Sundry ID: 2870520

Type of Action: Plug and Abandonment

HILCORP ENERGY COMPANY
MUDGE A 3
P&A NOI

Notice of Intent - Plug and Abandonment

MUDGE A 3 - PROPOSED WELLBORE SCHEMATIC

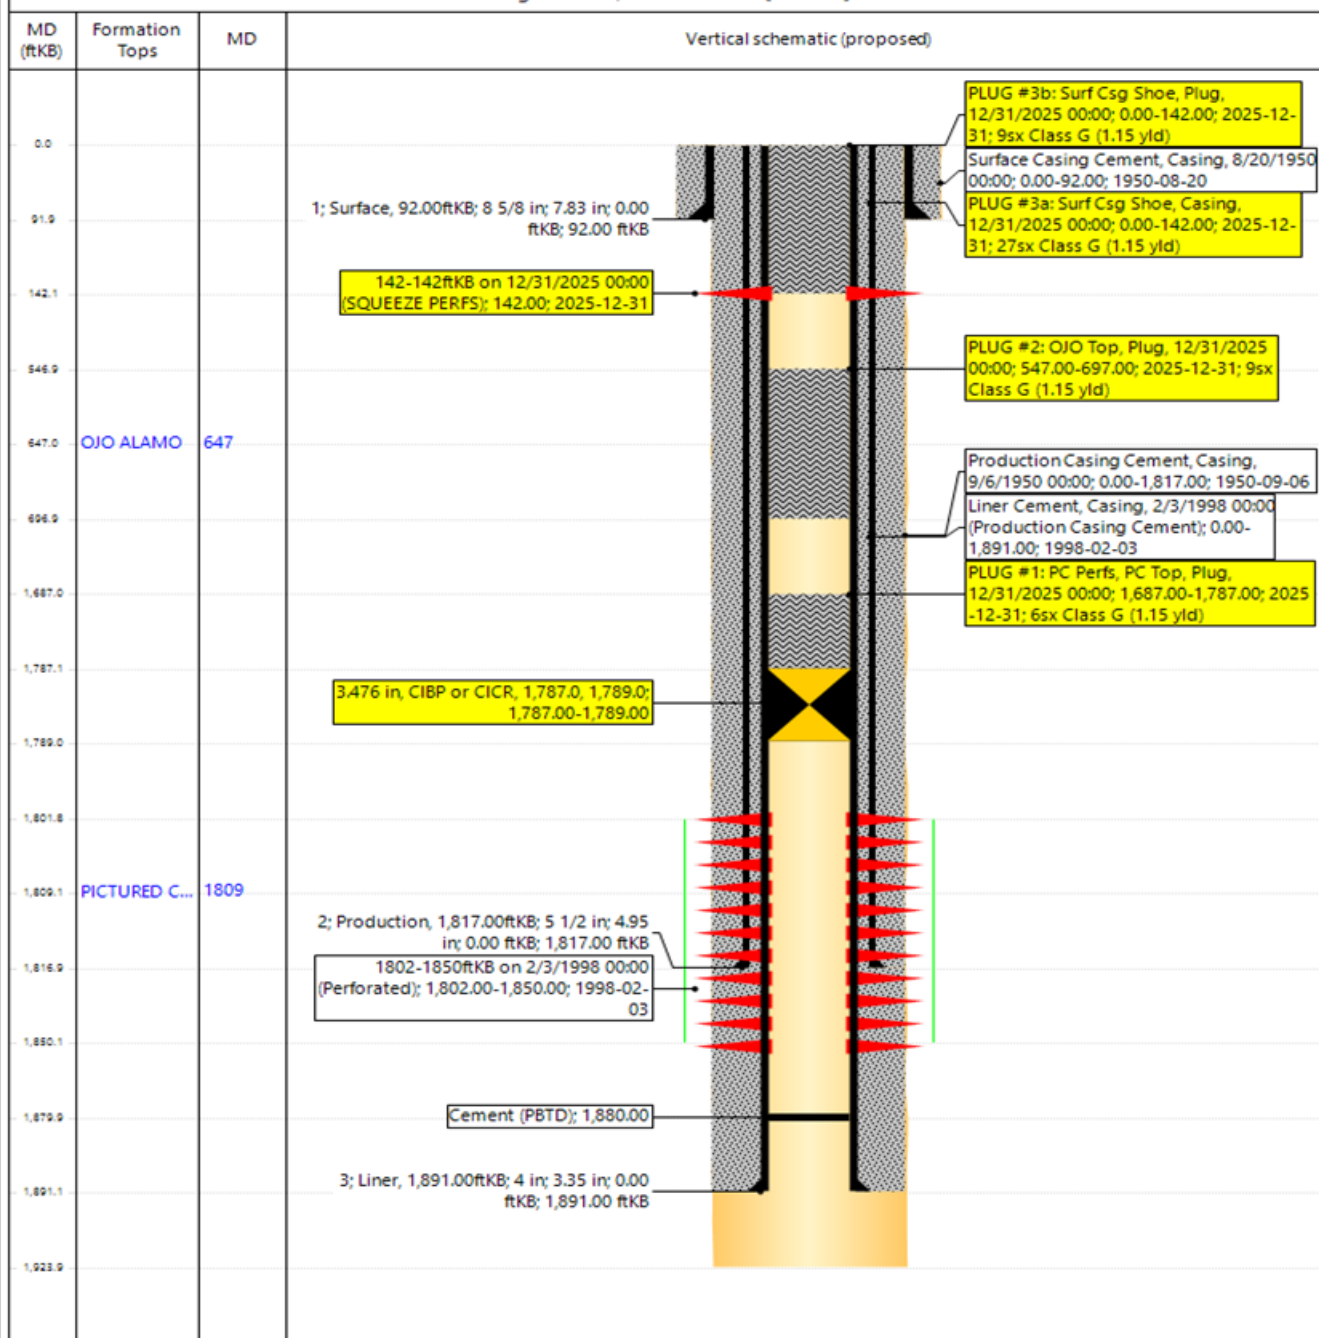
-Vertical wellbore, all formation depths are TVD from KB at the wellhead.
 Modify Plug 2: Make the TOC 513' to cover the BLM geologist's pick for the Ojo Alamo top.

3. **The following modifications to your plugging program are made:**
 - a. Add plug to cover BLM Geologist's Fruitland formation top pick @ 1383'. Plug should at a minimum cover 1283' – 1453', estimated minimum 9 sx Class G cement.

- b. Adjust Plug 2 (Ojo Alamo) TOC to 513' to account for BLM Geologist's Ojo Alamo formation top pick @ 613' and BOC to 788' to account for BLM Geologist's Kirtland formation top pick @ 738'. Plug should at a minimum cover 513' – 788', estimated minimum 17 sx Class G cement.

Created By	Condition	Condition Date
loren.diede	Notify the OCD inspection supervisor via email 24 hours prior to beginning Plug & Abandon (P&A) operations.	9/11/2025
loren.diede	Accepted for record.	9/11/2025
loren.diede	NMOCD requests that the Kirtland (740') and Fruitland (1250') formation tops also be covered with cement plugs	9/11/2025
loren.diede	Submit photo and GPS coordinates of the P&A marker with the final P&A reports. The API# on the marker should be clearly legible.	9/11/2025
